TABLE OF CHANGES FOR PLANNING
AMMENDMENTS: SECTIONS & ELEVATIONS

Project Title
T2 VITA LIVING, ST. JOHNS

Drawing Title
PROPOSED WEST ELEVATION

Drawing Number
6555-P-B500-E-W

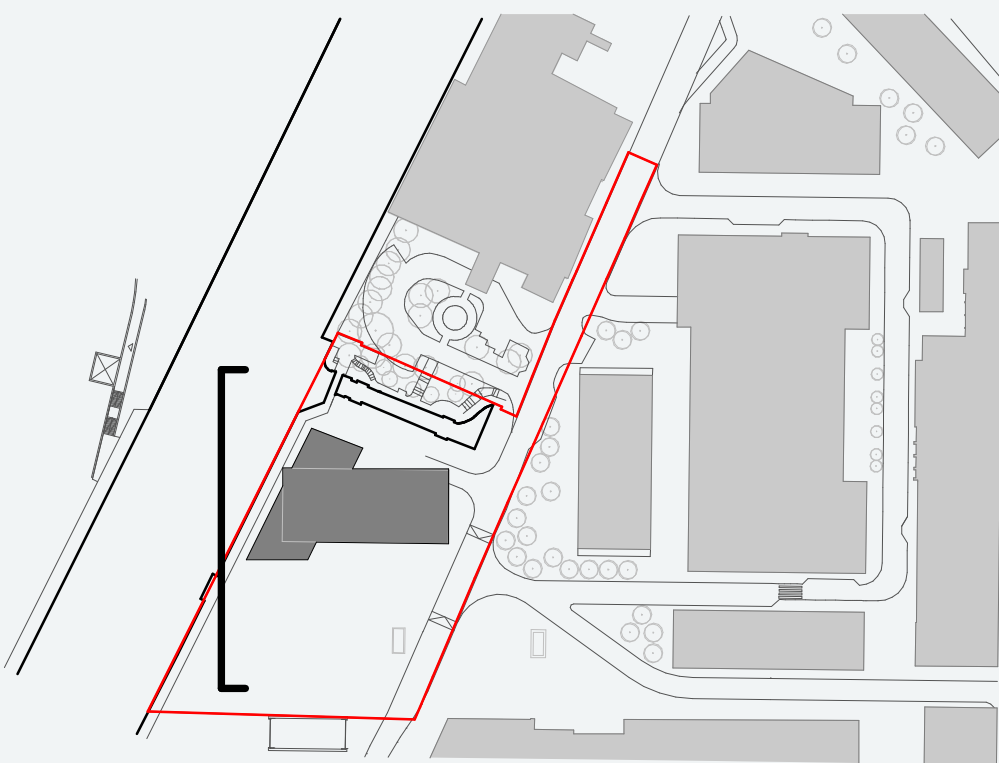
ITEM 5 BMU AMENDED
REFER TO TABLE OF
CHANGES

ITEM 3 CROWN HEIGHT
REFER TO TABLE OF
CHANGES

ITEM 4 APARTMENT WINDOWS
REFER TO TABLE OF CHANGES

ITEM 7 CORNER WINDOWS
AMENDED
REFER TO TABLE OF CHANGES

ITEM 2 FIRST FLOOR
ROOF TERRACE
REFER TO TABLE OF
CHANGES

ITEM 1 GROUND FLOOR
COMMERCIAL UNIT
REFER TO TABLE OF
CHANGES

- 1 - GROUND FLOOR COMMERCIAL UNIT**
GROUND FLOOR FOOTPRINT DEVELOPED TO INCLUDE COMMERCIAL UNIT
- 2 - ROOF TERRACE**
INTRODUCED AT LEVEL 01 WITH GLAZED PERIMETER BALUSTRADE

- 3 - CROWN HEIGHT**
HEIGHT OF CROWN REDUCED BY 1.31M
OVERALL BUILDING HEIGHT REDUCED TO 112M
- 4 - APARTMENT WINDOWS**
SIZE / CONFIGURATION OF APARTMENT WINDOWS TO RESIDENTIAL FLOORS AMENDED

- 5 - BMU AMENDED**
STATIC ROOF-MOUNTED MAINTENANCE UNIT (BMU) AMENDED TO MOBILE PERIMETER TRACK-MOUNTED TYPE BMU WHICH WHEN PARKED IS FULLY CONCEALED
- 6 - SPANDREL PANELS OMITTED AT LEVEL 01-04**
FIXED GLAZED SPANDREL PANELS TO BOTTOM OF LEVEL 01-04 GLAZED SCREENS OMITTED TO NOW MAKE THE SCREENS FULL HEIGHT

- 7 - GABLE FACADE AMENDED**
SIZE AND CONFIGURATION OF WINDOWS FIXED CLEAR GLAZING AND METAL FACADE PANELS AMENDED TO ALIGN WITH SPECIALIST DESIGN ADVICE
